**Item 10.1: AEPSC Sinton-Beeville-Kenedy  
Area Improvements Project  
Regional Planning Group (RPG) Review;  
ERCOT Independent Review**

**March 19, 2013**

## **AEPSC Sinton – Beeville – Kenedy Load Area Improvements Project**

Figure II: Approximate Location of Upgrades

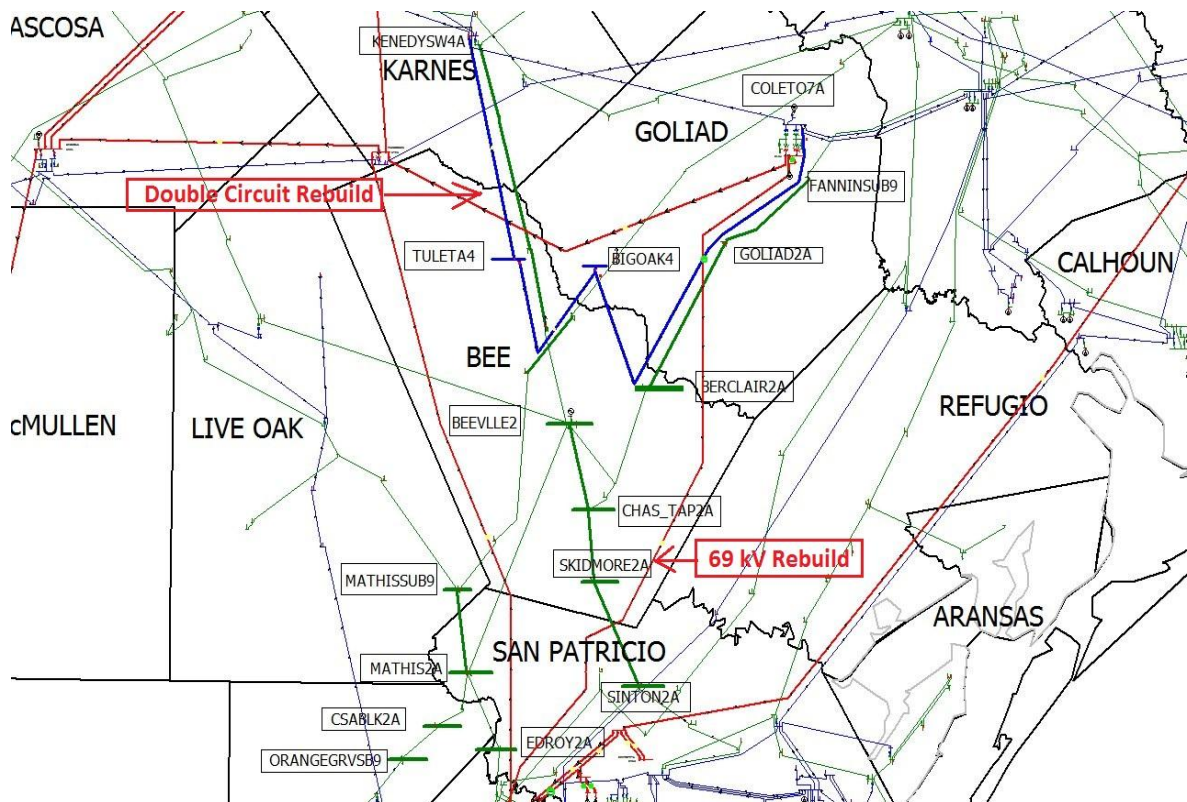
Figure II below shows the transmission topology related to Option 1 upgrades:

It should be noted that the upgrades discussed in Option 2 are similar to the upgrades discussed in Option 1 except the installation of phase shifting transformer (PST) at Sinton has been omitted.

It should be noted that the upgrades discussed in Option 3 are similar to the upgrades discussed in Option 2 except that the Edroy – Smith – Mathis 69 kV line was upgraded instead of installing a 15 Ohm series reactor at Edroy.

All three options studied resolved the identified reliability issues. Based on the cost estimates, Option 2 was preferred over Options 1 and 3. Upgrades discussed under Option 2 were studied for additional sensitivities.
